Independent Technical Review of Management of Stormwater and Wastewater at the Separations Process Research Unit (SPRU) Disposition Project, New York

Prepared by: The DOE EM Center for Sustainable Groundwater and Soil Solutions, Savannah River National Laboratory, Aiken SC

June 2011

Figure 1. Stormwater management system prior to D&D activities
(Source: Figure 3 URS, 2011).

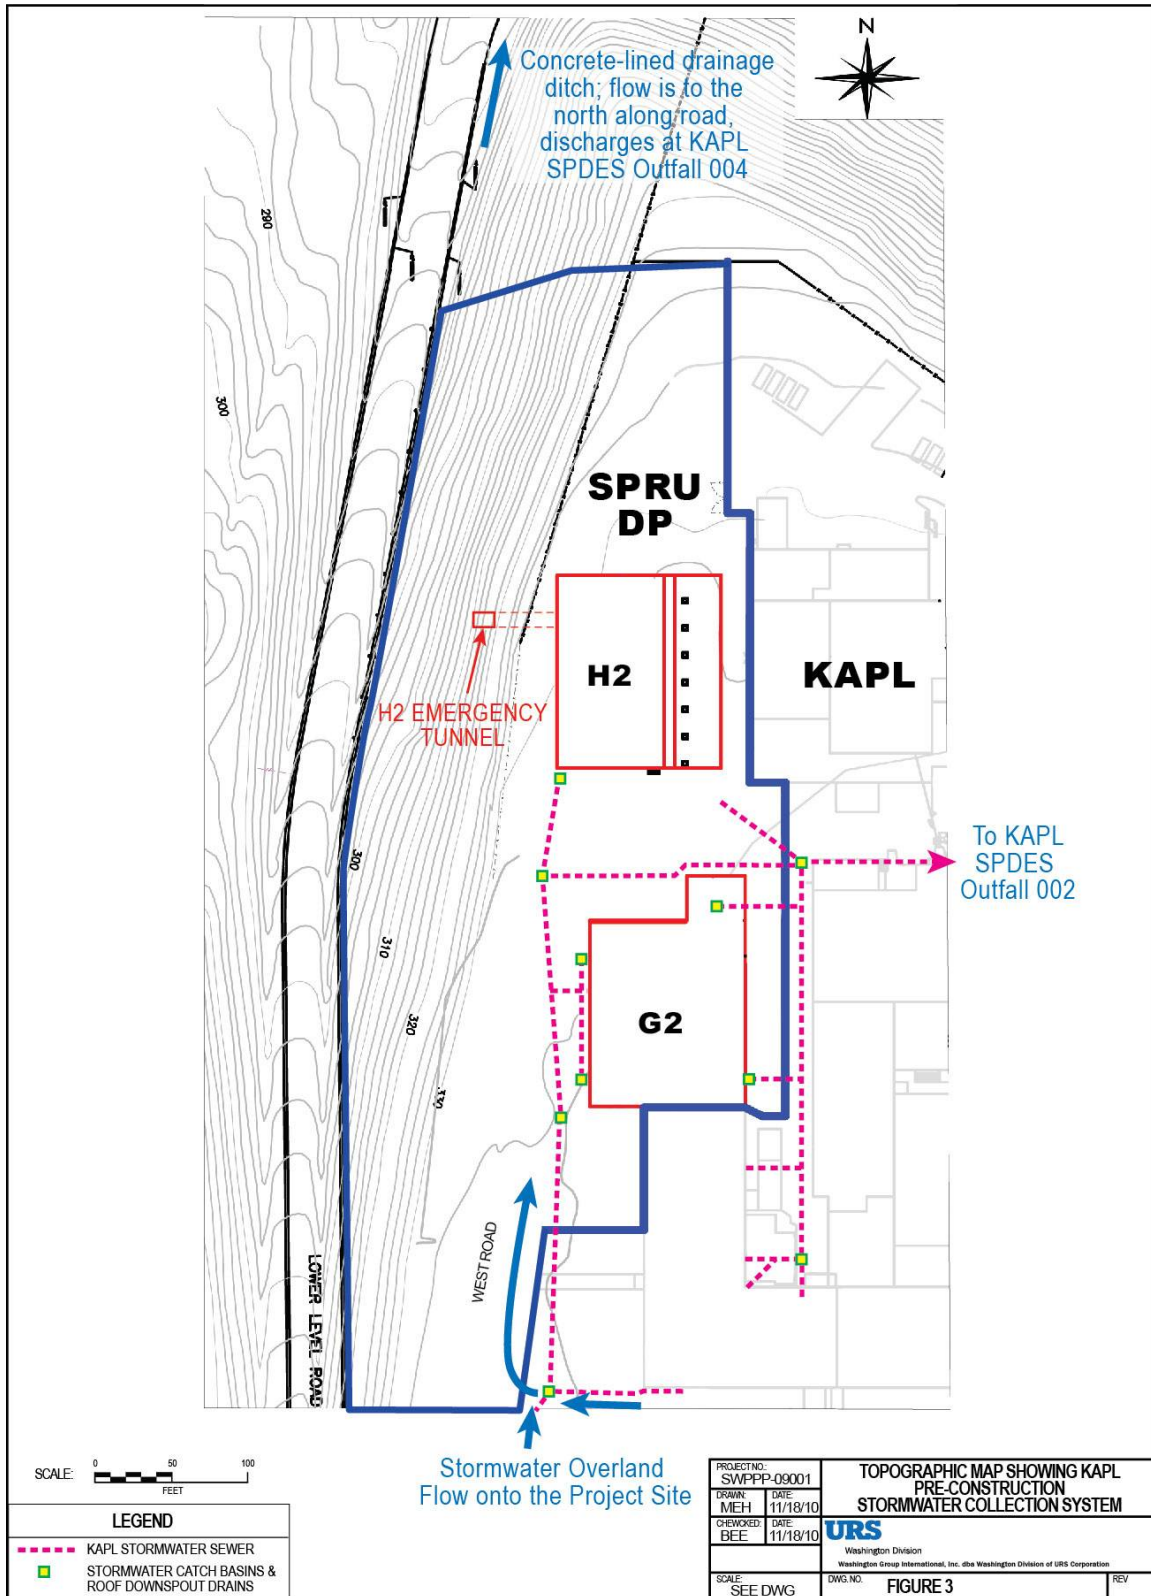
During their site visit, the team was able to walk down most of the site to observe the present stormwater and treatment systems. Figure 1 identifies the stormwater system prior to D&D activities and Figure 2 depicts conditions during D&D of the above-grade portions of Buildings G2 and H2. The team defined key components of the stormwater system in terms of potential inputs, flow vectors, treatment vectors, and final disposition options (Table 2). Potential inputs into the surfacewater/stormwater system that were identified include precipitation, dust control, runoff from pavement and roofs, the Hillside sump, and basement sumps in building G2 and H2. Flow vectors (KAPL Storm Sewers, French Drain System, Hillside Slope, Tank Cluster A and B) and treatment vectors (existing onsite ion-exchange system, proposed onsite ion-exchange system, and proposed onsite treatment system for volatile organic compounds) bridge the input streams to the waste disposition options. Final disposition options include the two KAPL outfalls (SPDES 002 and SPDES 004), percolation at the rail bed, and offsite treatment at either the DuPont or PermaFix facilities.

Prior to D&D activities, the stormwater treatment system was housed in the basement of Building H2 and operated at a nominal capacity of five to eight gpm. Precipitation events during a calendar year delivered 70,000 to 100,000 gallons of water to the H2 footer sump (personal communication from DOE-SPRU personnel), which sent the stormwater to the hillside sump collection point where it was pumped to the basement treatment system to remove radionuclides (primarily Sr-90 and Cs-137) and then transferred to a holding tank. Samples of the treated water were collected and sent to the KAPL analytical laboratory to demonstrate that radionuclide levels were low enough to discharge the treated water to one of KAPL's permitted stormwater discharge points (SPDES 002, see Figure 1).

Figure 2: Configuration for D&D prior to excavation to remove subgrade structures
(Source: Figure 8 URS, 2011).

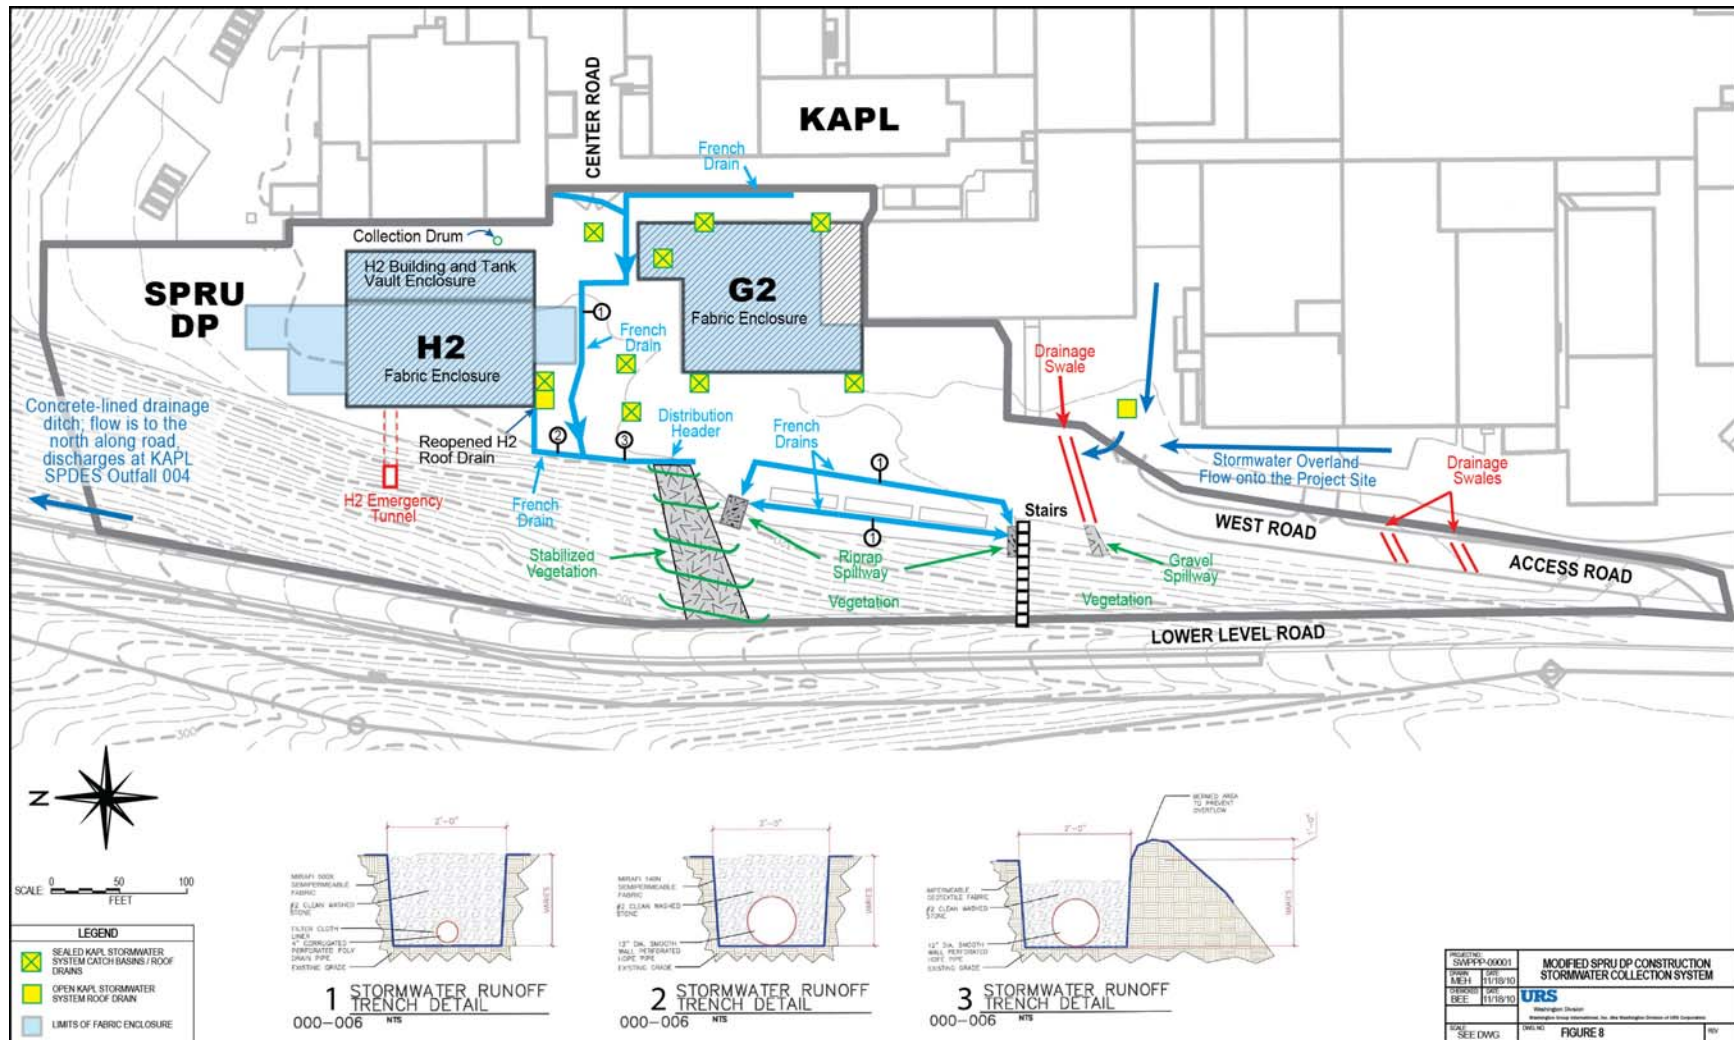
Figure 5 depicts the management of water as described by the Stormwater Pollution Prevention Plan (SWPPP) (URS 2011), and Figure 2 illustrates the layout of the French drains. Precipitation that falls on the proposed tent structure over Building H2 will be transferred to the KAPL storm sewer through the old stormwater inlet on the SW corner of Building H2. Rainfall on the pavement will primarily be collected in the French drains and conveyed to the hillside slope to discharge at SPDES 004, but some of this precipitation may percolate and reach the isolated storm sewer system and discharge at SPDES 002. It is important to note that the French drain system uses a semi-permeable geofabric for the majority of the network, specifically for those sections in and around the G2 and H2 buildings.

Precipitation that falls on the areas around the buildings at the SPRU site is directed primarily to the French drains, where it is delivered to the hillside slope for discharge at SPDES Outfall 004 (Figure 2). The H2 footer drains/Hillside sump and the H2 and G2 basements receive water from precipitation falling on and near the building footprints. Since the French drain system was installed with a semi-permeable membrane, it is very likely that a significant portion of the water gets diverted via percolation to the subsurface and some of this reaches the H2 footer drains, the KAPL storm sewer, and/or to the H2 basement during extreme precipitation events. Impervious mats placed on the ground surface east of the tank vault attached to Building H2 (Figure 2) are sloped into the east wall of the tank vault, and precipitation falling in this area is channeled into the H2 footer sump (Figure 8). In addition, since the previous impervious surface has been significantly altered, infiltration into the subsurface has likely increased. The increased infiltration interacts with residual VOCs and radionuclides in soil and gravel beneath the surface and reaches the Hillside sump via the H2 footer sump. The additional VOC constituent prevents disposal of wastewater to the KAPL storm sewer since the H2 treatment system does not address these constituents.

Figure 4: Configuration of the Stormwater Management System Prior to D&D Activities.

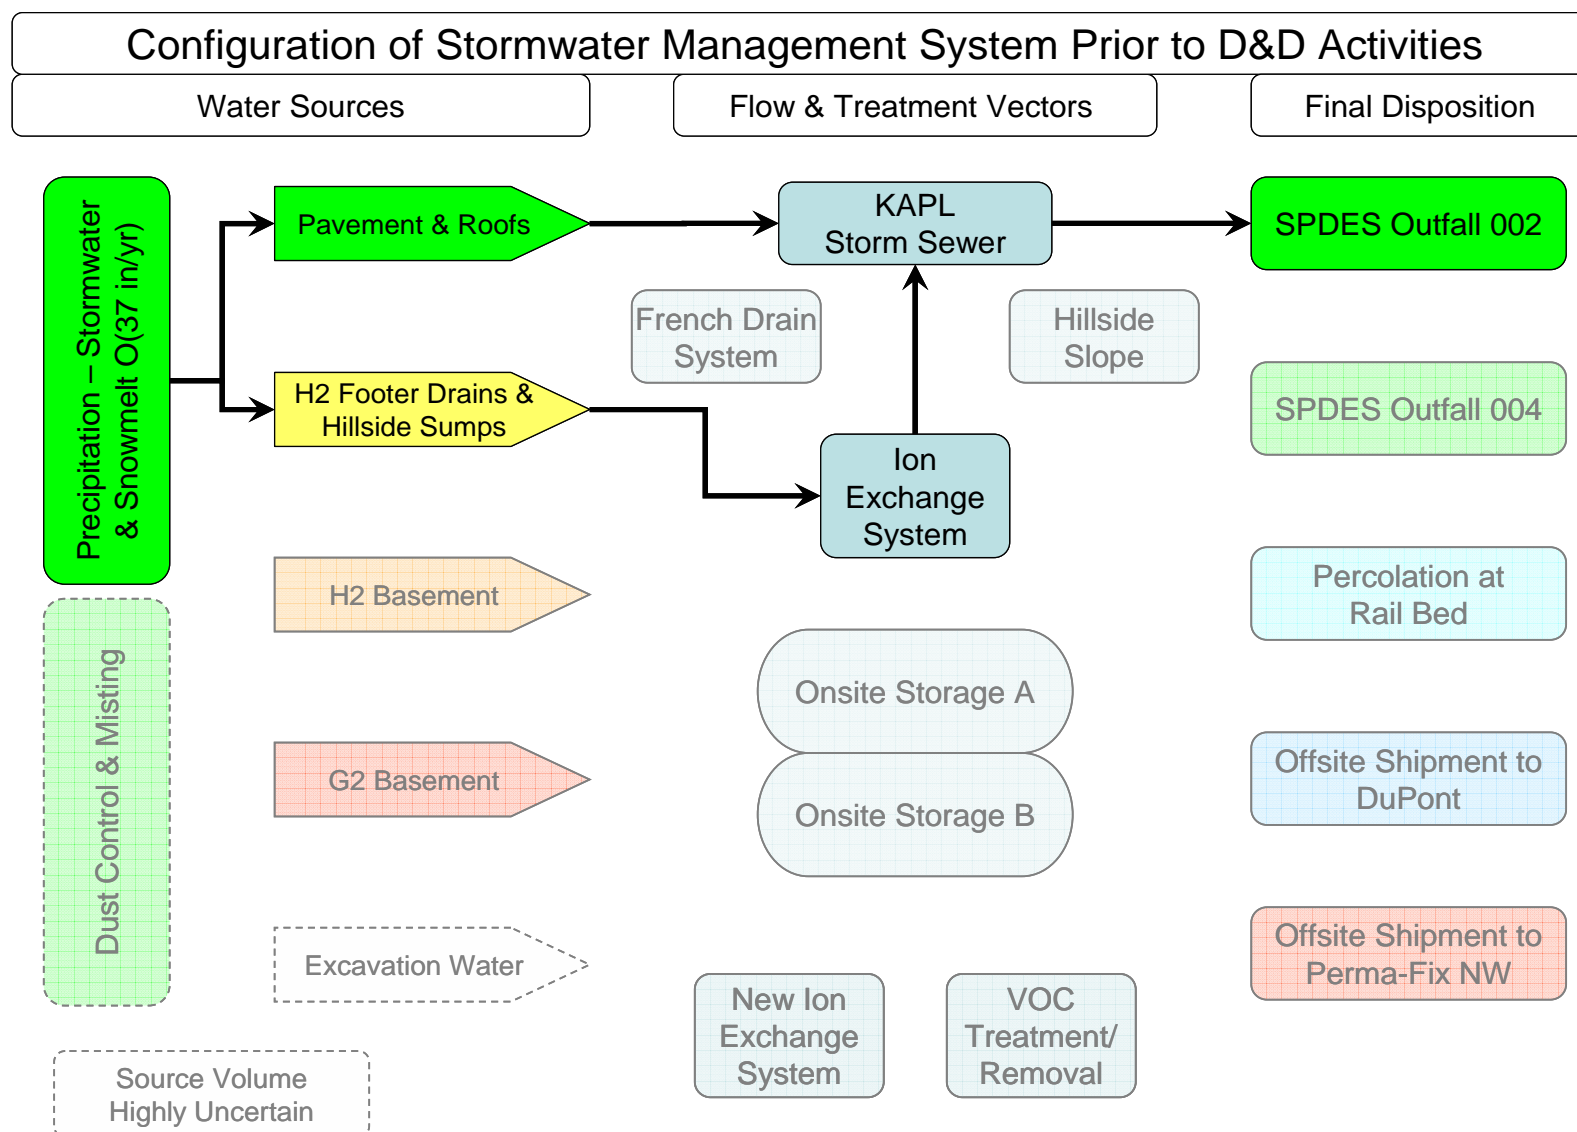
Figure 4 diagrams the flow of stormwater prior to D&D activities. The majority of the precipitation that falls on the roofs and pavement around Buildings G2 and H2 is collected using a network of retention basins (storm sewer type structures) and directed to the KAPL storm sewers (Figure 1), which then discharges to SPDES Outfall 002. In addition, water that falls on the grassy western hillside is routed north for discharge at SPDES Outfall 004. For clarity, Figures 4 through 7 do not illustrate the stormwater that falls directly on the western hillside because it has not been processed with any of the infrastructure at the SPRU facility.

Around buildings G2 and H2, some of the precipitation percolates through the surface to reach the footer sump around Building H2, and this drains via gravity to the Hillside sump, where it is pumped back to the basement of Building H2 for treatment. The Hillside sump water is passed through an existing ion-exchange system and the treated water is held in a tank for sampling and analysis prior to discharge to the KAPL storm sewer, with subsequent discharge to SPDES Outfall 002.

DOE personnel at the SPRU site indicate that historically 70,000 to 100,000 gallons a year were collected in the Hillside sump and transferred to the H2 basement for treatment. Given the surface area of the H2 and G2 footprints and the surrounding asphalt areas (URS 2011), and an annual precipitation of approximately 38 inches, the estimated volume of water going to the KAPL storm sewers around Buildings G2 and H2 (Figure 1) was 1,400,000 gallons a year. This suggests that prior to D&D, less than one percent of the annual stormwater was collected in the Hillside sump and treated.

Figure 5: Configuration of Stormwater System Based Upon Current Stormwater Pollution Prevention Plan.

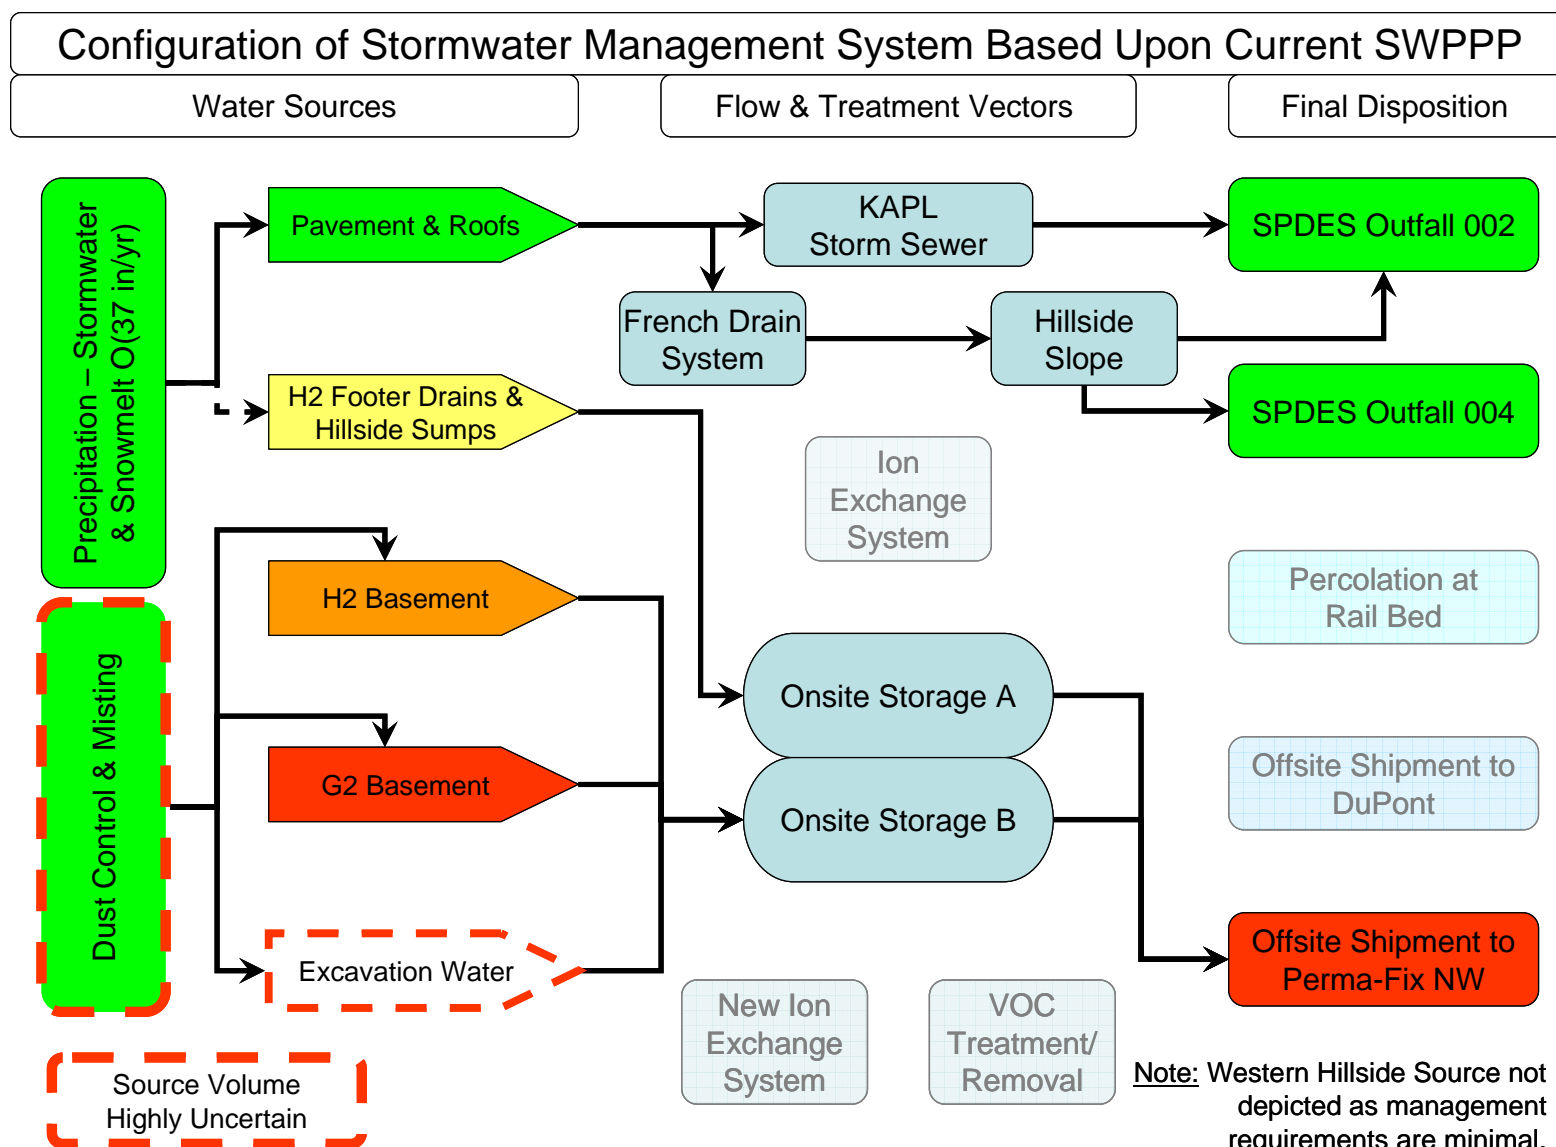
The SWPPP describes precipitation generating wastewater in the Hillside sump and the excavations that will be created to remove the subgrade structures of G2 and H2. These wastewater streams, along with water that has collected in the basements of Buildings G2 and H2 from D&D misting operations within the fabric enclosures, will be conveyed to holding tanks and shipped offsite for treatment and disposal.

Figure 6: Current Configuration of Stormwater Management System (Observations May 23-25, 2011).

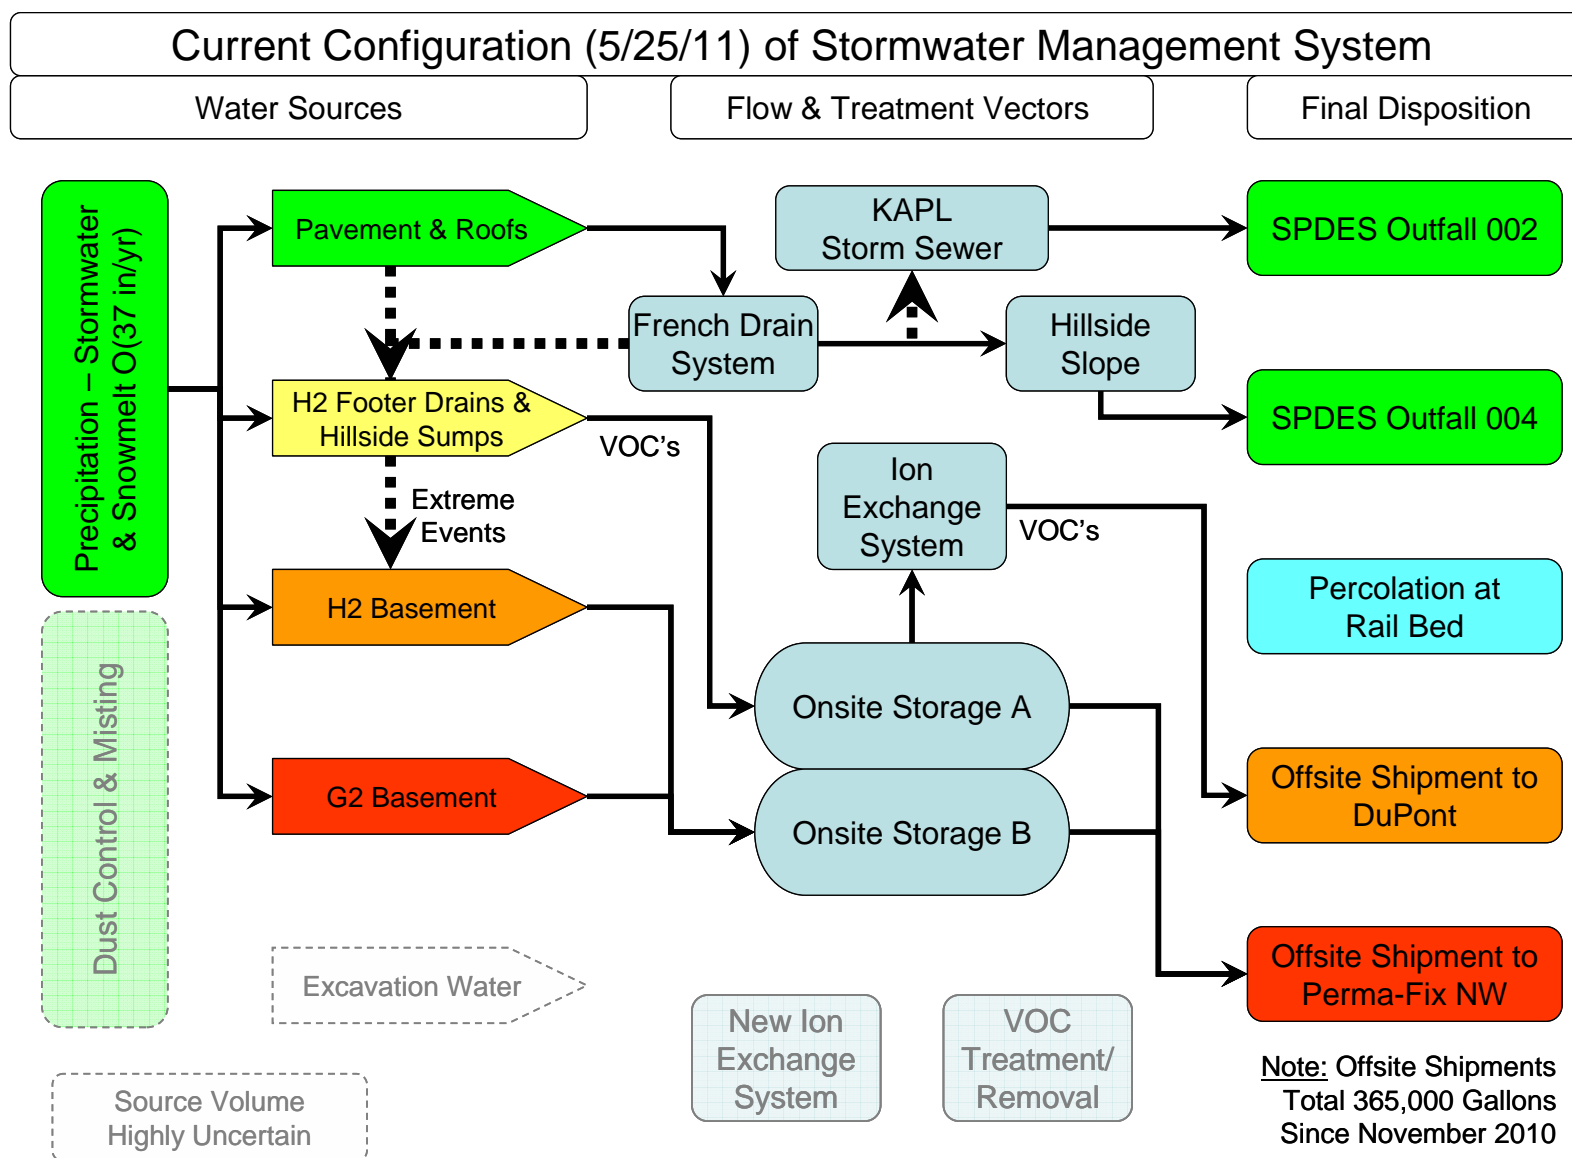
Figure 6 presents the current conditions of the stormwater management system based upon observations and interviews conducted May 23 – 25, 2011. Pathways not identified in the SWPPP but that are considered to exist based upon observations and document reviews are illustrated as dashed lines in Figure 6.

Wastewater in the Hillside sump is pumped to Tank Cluster A, where it may be treated and then shipped to the DuPont facility in NJ or directly shipped as untreated water to PermaFix NW. Precipitation falling on the exposed interior portions of Buildings G2 and H2 is collected in the respective basements and pumped to Tank Cluster B, where it is sampled, analyzed and shipped untreated to PermaFix NW.
